GOVERNMENT OF THE DISTRICT OF COLUMBIA  
DEPARTMENT OF TRANSPORTATION

**MEMORANDUM**

**SUBJECT:** ZC Case No. 15-27 – 300 Morse Street NE

Figure 1 Site Design and Access (Source: Gorove/Slade)

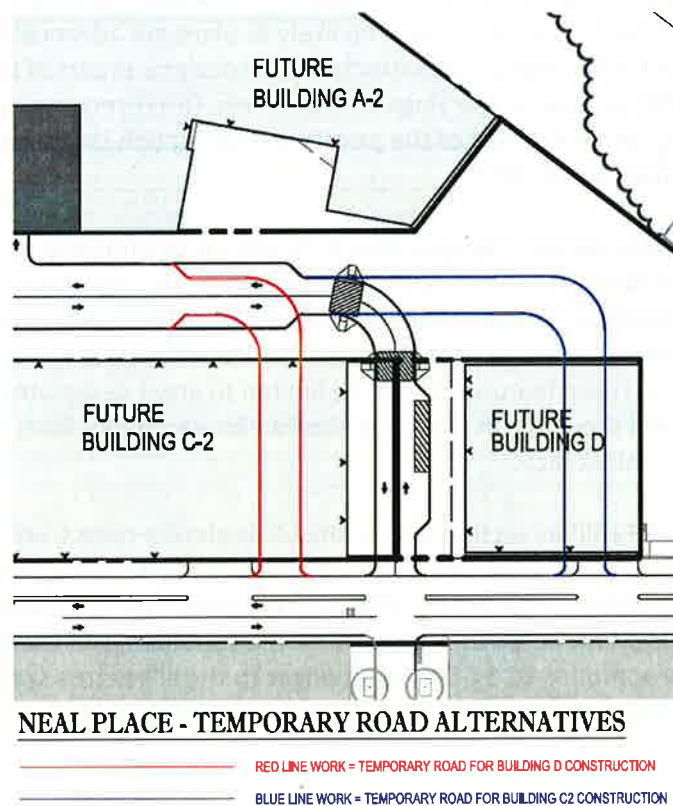
The Applicant proposes several new private streets that connect the site to the existing street grid as shown in Figure 1. A new 3<sup>rd</sup> Street NE is proposed as the site’s major north-south transportation facility and will connect to the adjacent street network via extensions of Morse Street and Neal Place. In addition, the development takes advantage of a private north-south alley between the future 3<sup>rd</sup> Street and 4<sup>th</sup> Street to provide site access to buildings C-1, C-2, and D.

The new street network has the potential to disperse site traffic throughout the site in a way that minimizes the action’s impact on the road network in the vicinity. The new roads serve as vehicle, bicycle, and pedestrian access points for the site. All streets are proposed to be private but are expected to meet DDOT construction standards. Of note, as private streets, the Applicant is responsible for maintenance, snow removal, and curbside management and enforcement.

The new streets are proposed to be constructed in a phased approach aligned with the vertical construction of the site. Morse Street and 3<sup>rd</sup> Street are proposed to be constructed as part of Phase 1. The Applicant’s plans are not clear regarding phasing of transportation infrastructure improvements, and additional clarification is needed. DDOT’s current understanding of the phasing plan is as follows: a

temporary Neal Place connection between 3<sup>rd</sup> Street and the alley and alley improvements along the rear of C-1 is also proposed as part of Phase 1. The temporary Neal Place will be aligned with Neal Place to the east. Phase 2 would include the construction Neal Place in its final condition and the remainder of the alley improvements behind buildings C-2 and D. DDOT expects that the entirety of 3<sup>rd</sup> Street and the alley improvements between Morse Street and Neal Place be implemented in their final condition as part of Phase 1

- The new streets are proposed to be constructed in a phased approach aligned with the vertical construction of the site. The Applicant's plans are unclear regarding the proposed phasing of transportation infrastructure improvements. DDOT expects that the entirety of 3<sup>rd</sup> Street and the alley improvements between Morse Street and Neal Place be implemented in their final condition as part of Phase 1;

Figure 7 Proposed Private Alley Plan

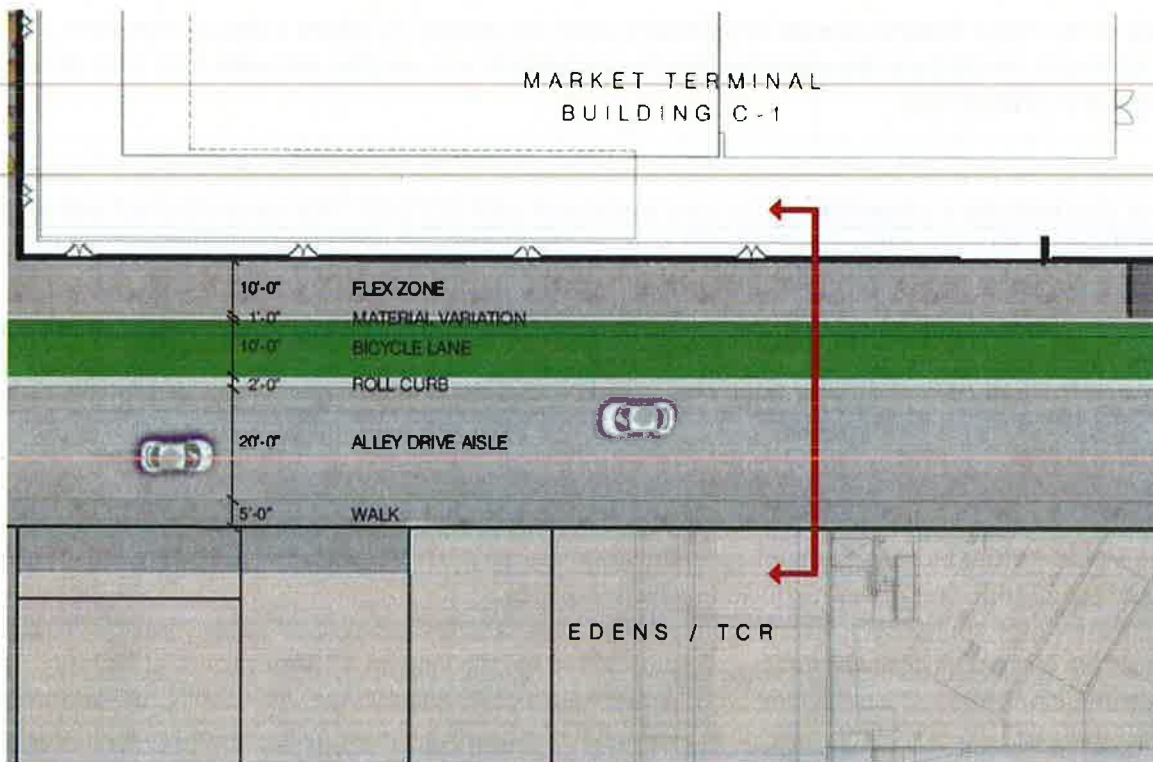
As is discussed in the Bicycle Facilities section below, site plans show a cycle track in the private alley, consistent with DDOT direction. The proposed cross section deviates from the alley treatment proposed and approved as part of ZC 14-07. At the time of this report, the Applicant is still in the process of coordinating with the applicant for ZC 14-07 to determine the consistency of the proposed alley cross section with the previously approved ZC 14-07. Any changes to the alley cross section must include an approximately 12' cycle track, and plans must be coordinated with DDOT to ensure best practices cycle track design are included.

Site plans submitted with the subject application show the inclusion of a cycle track in the private alley, consistent with DDOT direction. This facility, designed with a 2' raised buffer to separate bicycle traffic from vehicular traffic, will serve as a portion of a planned New York Avenue NE trail intended to connect to the National Arboretum. The Applicant and DDOT coordinated on a cross section for the alley that accommodates a sufficiently-wide drive aisle for trucks and vehicles, a cycle track as directed by DDOT, as well as a sidewalk adjacent to Buildings C-2, C-2, and D desired by the Applicant. The proposed cross section is shown in Figure 7.

As noted in the Site Design section, the proposed cross section makes changes to the alley treatment as proposed by ZC 14-07. At the time of this report, the Applicant is still in the process of coordinating with the applicant for ZC 14-07 to determine the consistency of the proposed alley cross section with the previously approved ZC 14-07.

- Cycle track design: Construct a 10' cycle track in the alley featuring a 2' raised buffer to separate bicycle traffic from vehicular traffic and a 1' buffer to separate bicycle traffic from pedestrian traffic. Breaks in the barriers should be provided to accommodate loading and vehicle access points for Buildings C-1, C-2, and D.
